## CITY PLANNING COMMISSION AGENDA

ITEM NOS: 5.A-5.E

**PROJECT:** THE RENAISSANCE AT INDIGO RANCH

DEV'T PLAN FIGURE 3

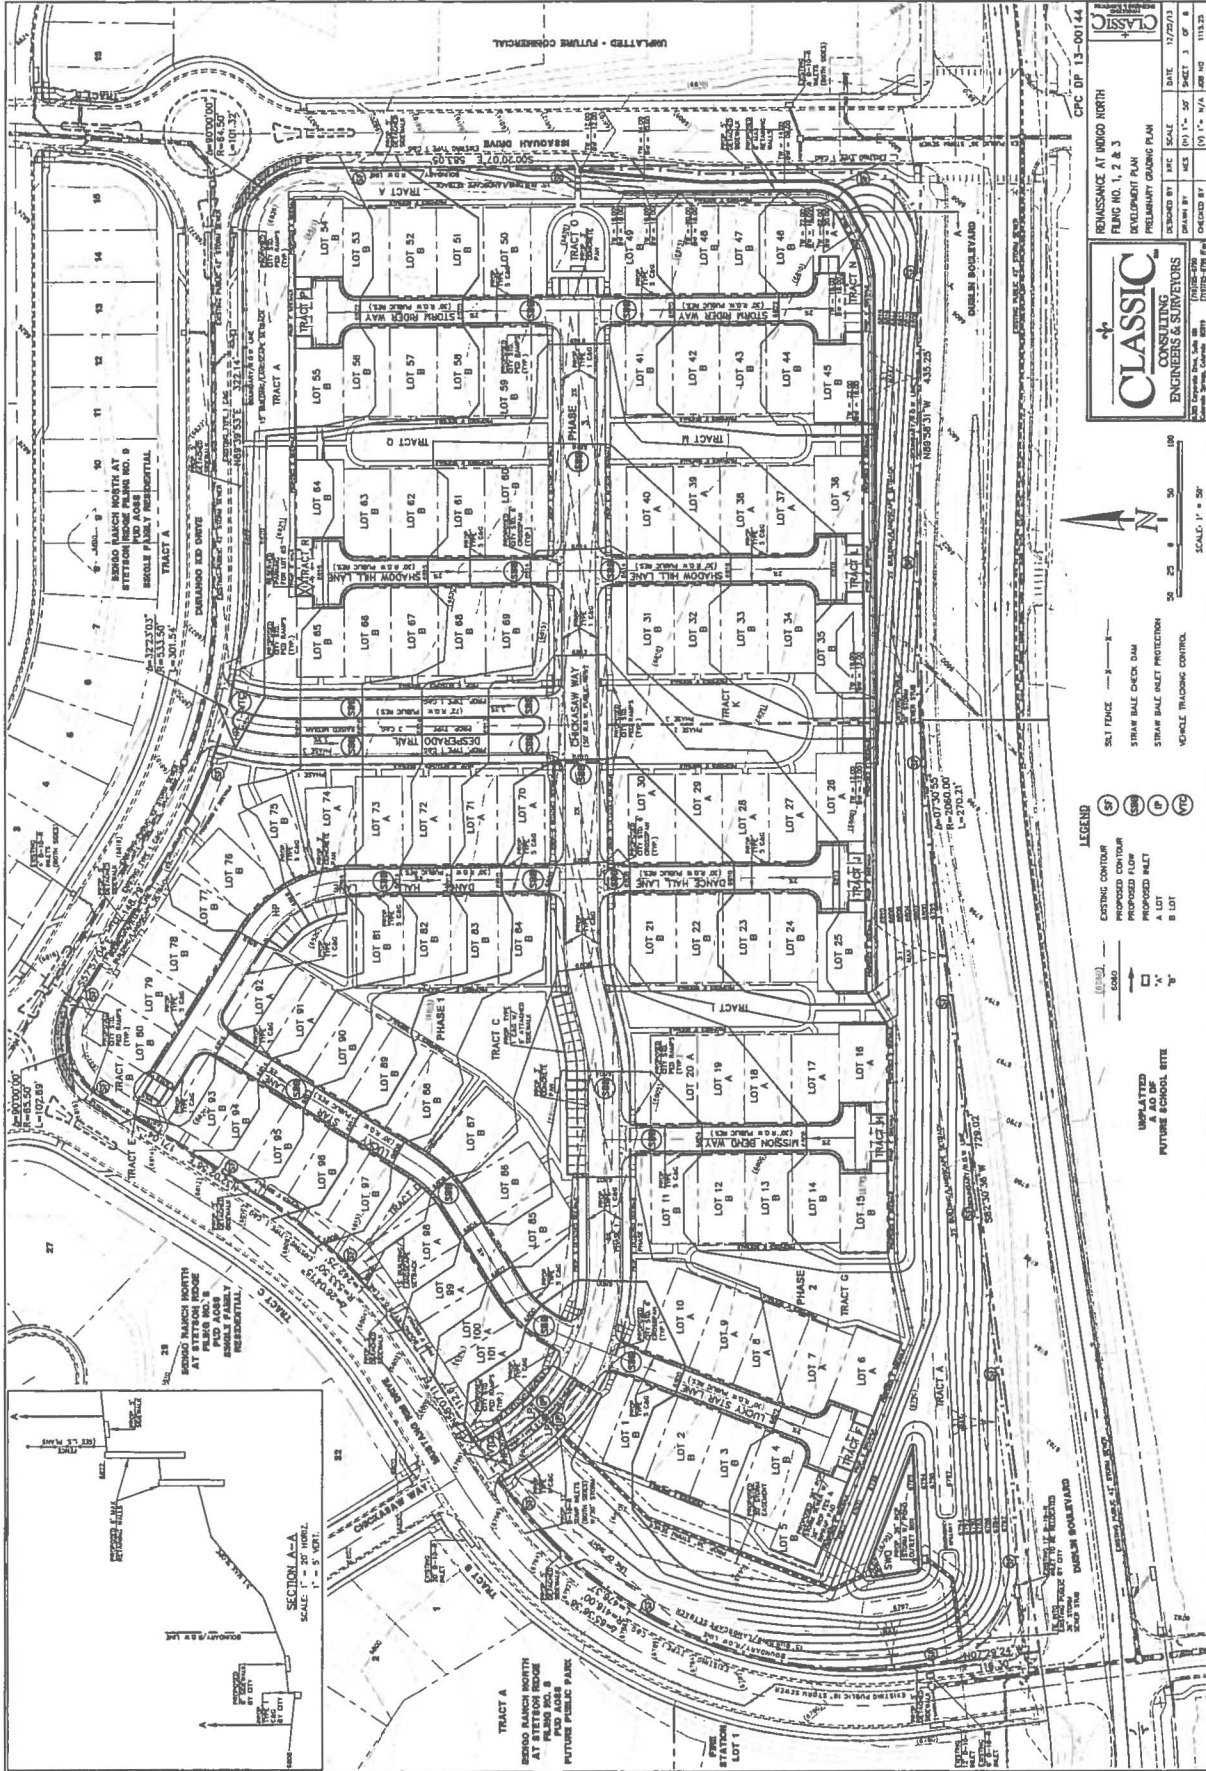
Within Chaparral Point, the internal rear access roadways are continuous and connect with a looped system. Within this proposal, many of the units are accessed with dead end streets (called "access" streets with a 22 foot mat/27 foot width to back of curb); however the number of units being served by the dead end streets is limited to not more than 10. The dead end streets do reduce the amount of pavement and provide adequate access to the units. City Engineering and Fire support this concept as public streets.

The second deviation is the number of units that do not actually front onto a greenway. The design manual limits the amount of non-greenway units to 10%; this proposal includes approximately 20% non-greenway units. While the non-greenway units do not have front loaded garages (all garages accessed in the rear), they do orient toward a street instead of a greenway. The minimum greenway width called out within the manual is a 40-foot width. Many of the units that do not face the greenway are along the two adjoining collector streets, Mustang Rim and Issaquah Drive.

Noise issues are one of the review criteria that deserve discussion. The typical standard to address noise is the construction of a noise wall and additional setbacks. While the setback area for this development is significant adjacent to Dublin, the applicants are not installing a noise wall and the grade actually rises from the road to the finished units. Instead, the applicants had a noise study completed to address this issue. Apparently the results indicate that additional soundproofing is necessary for those dwellings adjacent to Dublin. Staff has requested a copy of the study and a proposed technical modification below is suggested to update the development plan to address the necessary noise mitigation.

1. Sound study information from LSC was not provided. The development plan needs to include information as to specific units that are subject to additional sound attenuation. Provide a copy of the study and indicate on the development plan the affected units and the necessary noise mitigation.
  2. Provide a detail of the retaining walls (materials).
  3. Address the items noted by the Landscape Architect consisting of the following:
    - a. Include all street names and classifications on the landscape plan.
    - b. Show all Landscape categories requirements (setbacks, internal, and buffers if there are commercial uses across the non-arterial).
  4. Provide a letter from the Metro District which indicates that they will accept all responsibility for the ownership and maintenance of properties as noted on the plan.
-

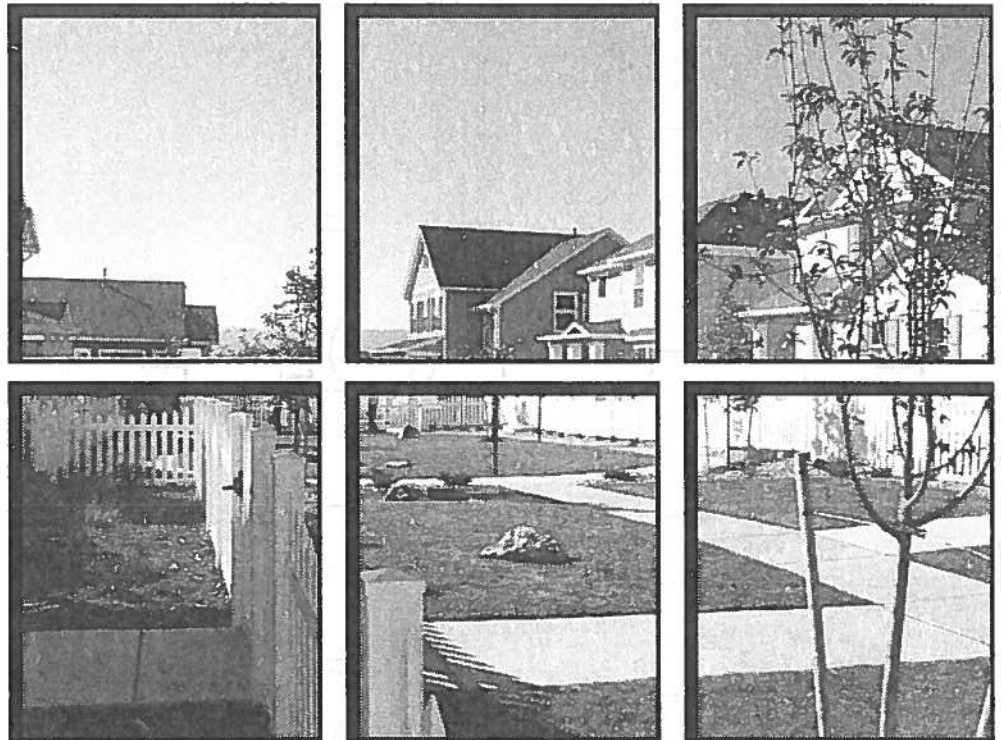
Capacities of the schools that will serve this proposed development have surpassed their design limit. Accelerated residential growth and strong growth potential heighten the School District's concern regarding its ability to provide adequate educational opportunities.

Based upon our calculations, land dedication is not feasible from a development of this size. District 49 cautiously approves the Zoning Change, with the clear understanding of the infrastructure capacity being inadequate and requests that the developer agree to pay cash in lieu of land at the current market value of land within the District. The District would like the opportunity to respond to any land use changes associated with this project.
